Applies To: **2007 RDX** – See VEHICLES AFFECTED

November 22, 2006

Safety Recall: Accessory Trailer Hitch Is Incorrectly Welded

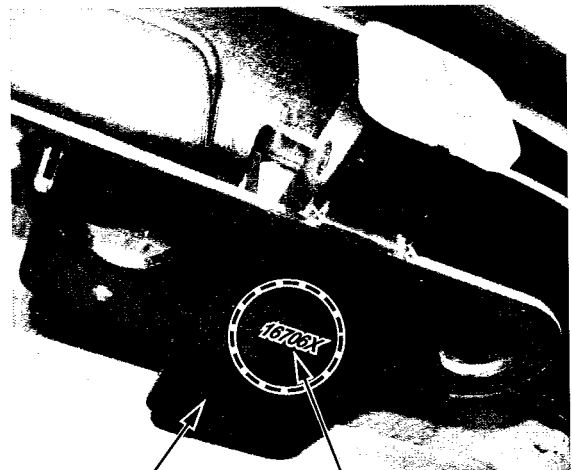
Check the date code stamped on the bottom of the trailer hitch:

NOTE: The fourth and fifth digits (06) represent the year 2006. No other years are affected.

- If the first three digits of the date code are lower than 177 or higher than 189, the trailer hitch is OK. Go to step 3 of REPAIR PROCEDURE.
- If you cannot read the date code, or if the first three digits of the code are 177 thru 189, go to REPAIR PROCEDURE.

This trailer hitch is not affected.

"16706X"
